**DESIGN/DEVELOPMENT REVIEW COMMISSION
DESIGN REVIEW DISTRICT
EVALUATION SHEET
Case #3**

ADDRESS: 1221-1301 Huger Street; 401-433 Gervais Street

NATURE OF REQUEST: Request for Certificate of Design Approval for Building One and Building Two

FULL ELEVATION - SOUTH 1
1/16" = 1'-0"

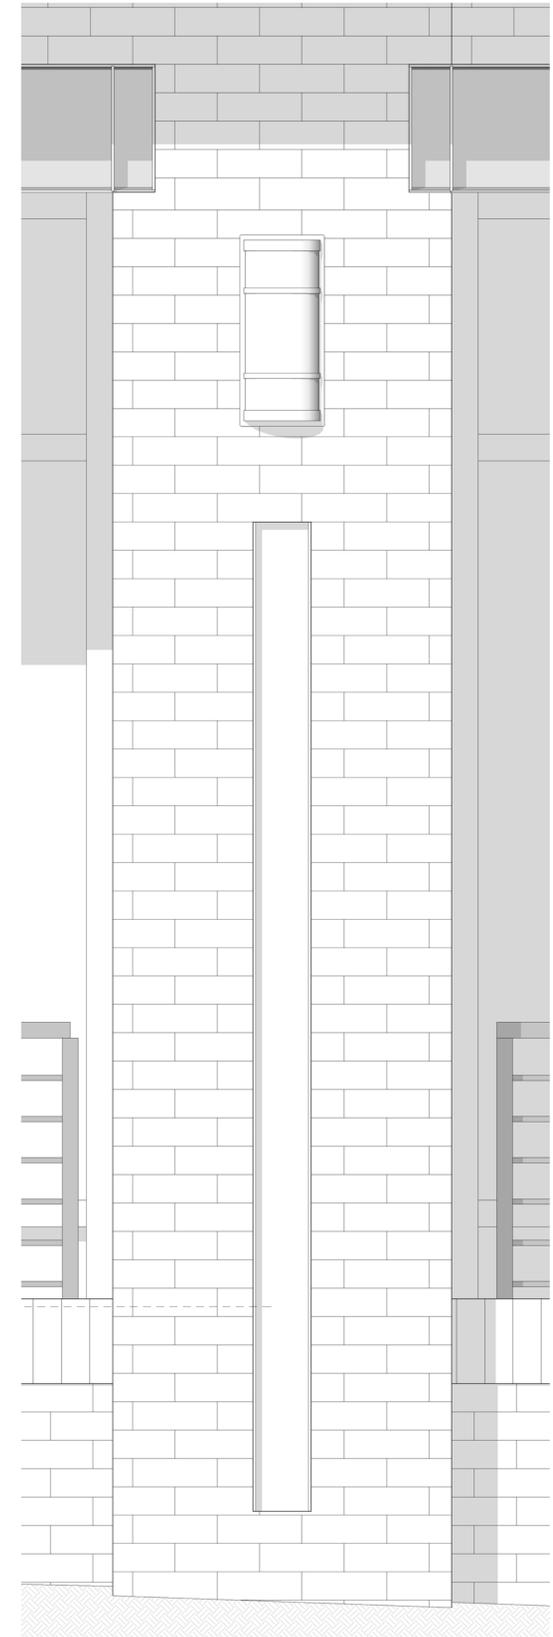
The Lady Street (south) elevation of Building One continues the steel detailing and planter boxes along the commercial storefront. A terraced planter has been added in front of the residential balconies that are high above the sidewalk to break up the monotony of a large blank wall.

The elevation of the western end of the Lady Street elevation has not been shown as an enlarged elevation; the terraced planter that was shown on the previous drawings is hard to decipher.

A13 - 1/8" Round x 3/16" Staggered Centers - 40% Open Area A25 - 3/8" Round x 9/16" Staggered Centers - 40% Open Area A24 - 3/8" Round x 1/2" Staggered Centers - 51% Open Area

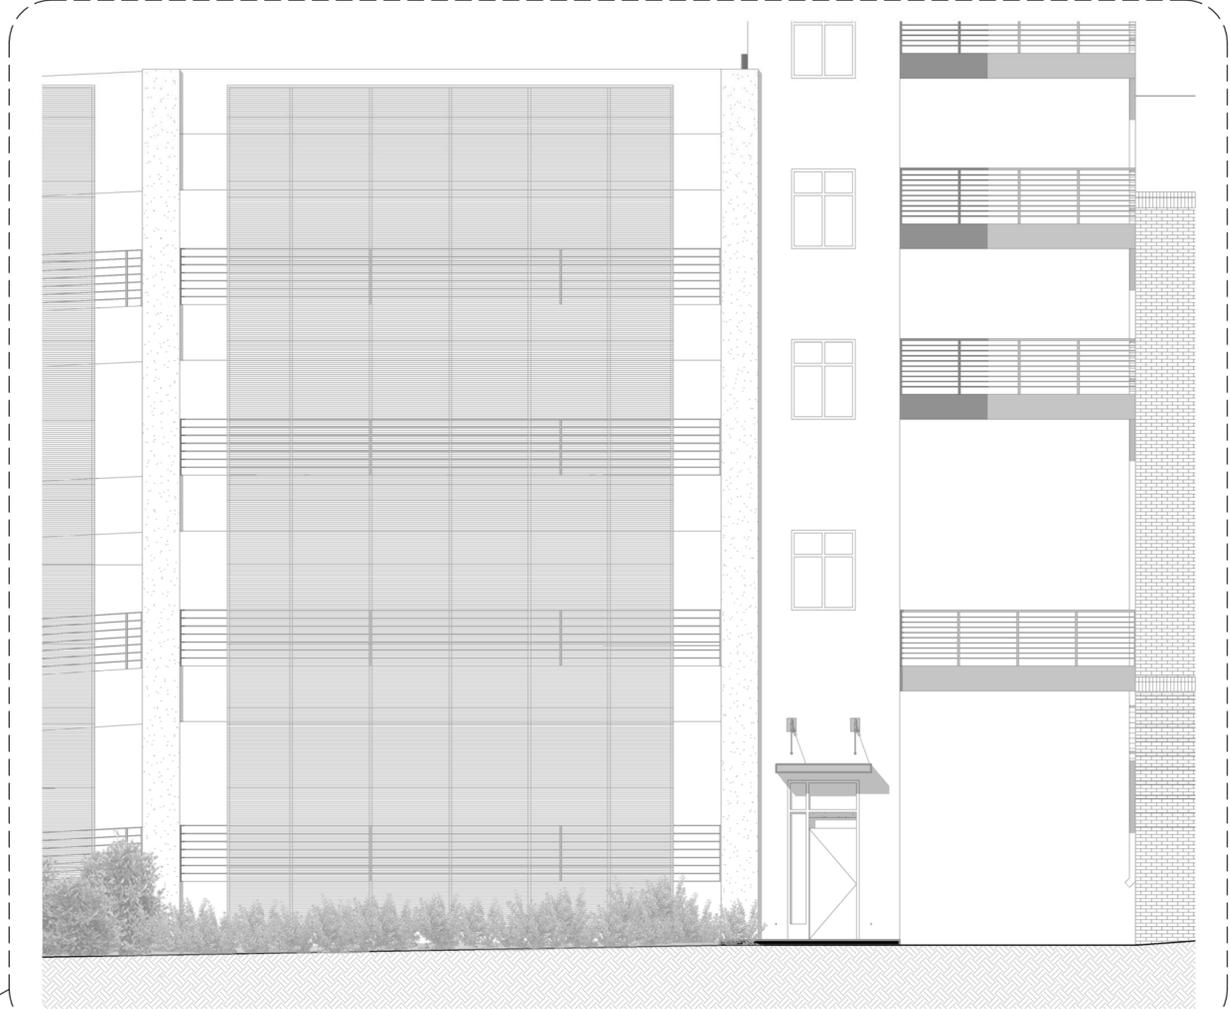
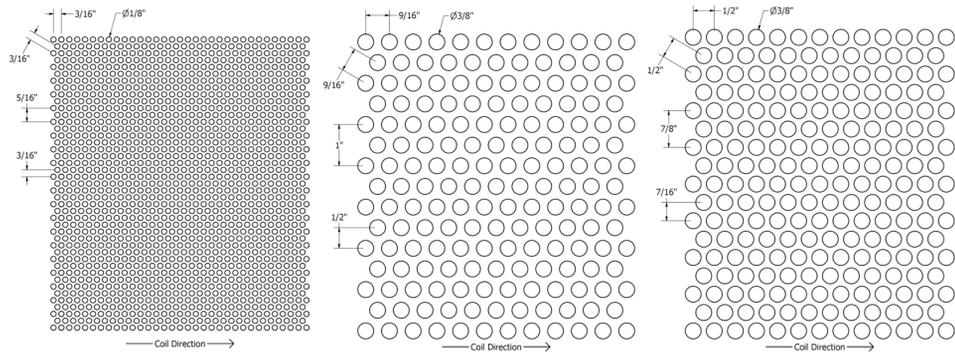
The exposed sides of the parking garages are screened with perforated metal panels. More details should be provided for review as they are developed.

FULL ELEVATION - WEST 1
1/16" = 1'-0"

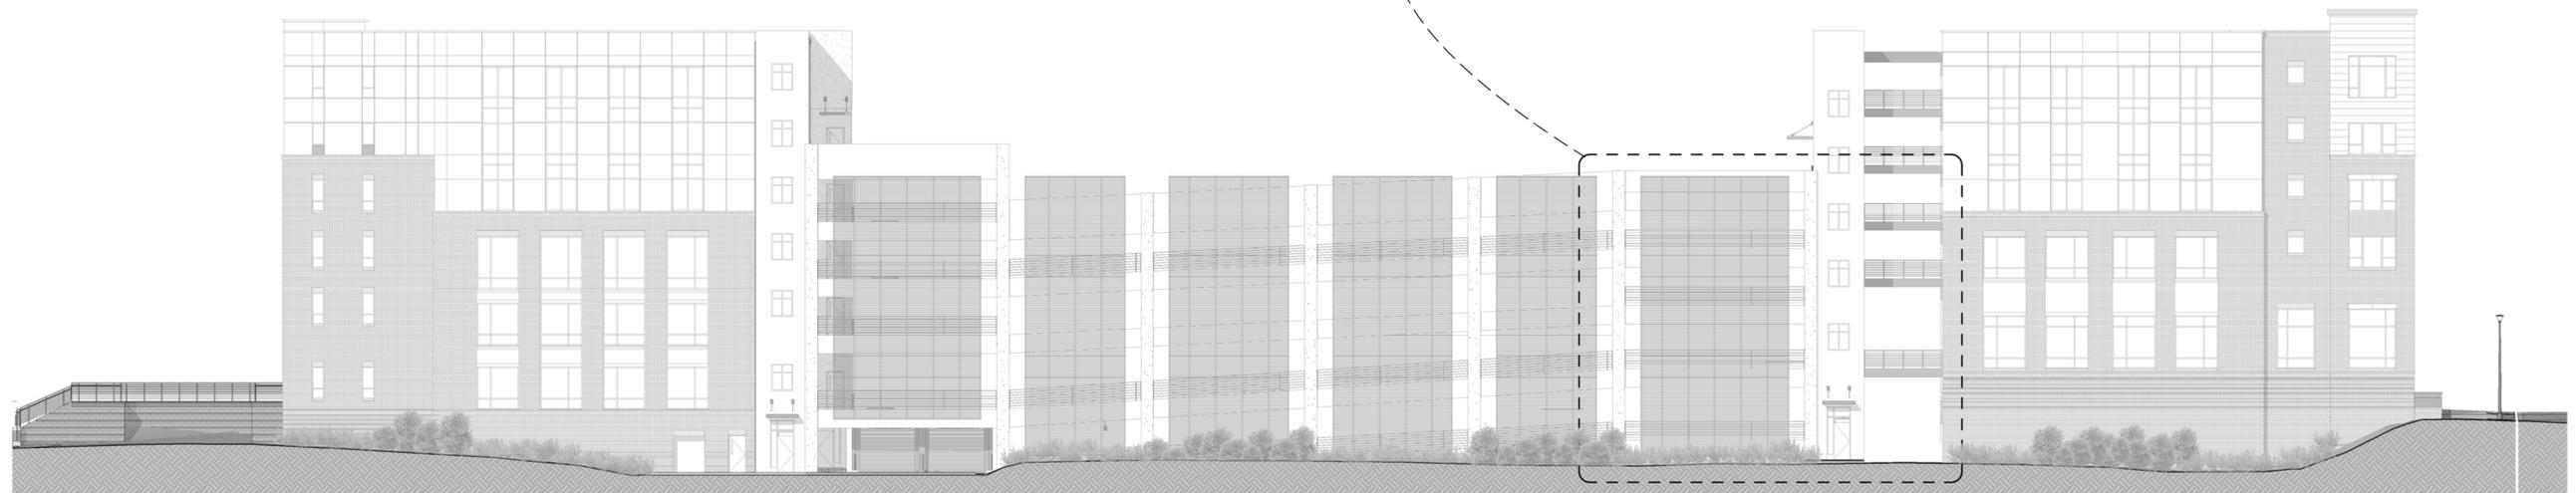
The parking garage design as submitted lacks articulation and detail. For the amount of area that this western elevation exposes to the State Museum, more articulation will be required.

More information is needed about the west façade of the Building Two garage to ensure the ramping is screened from view.
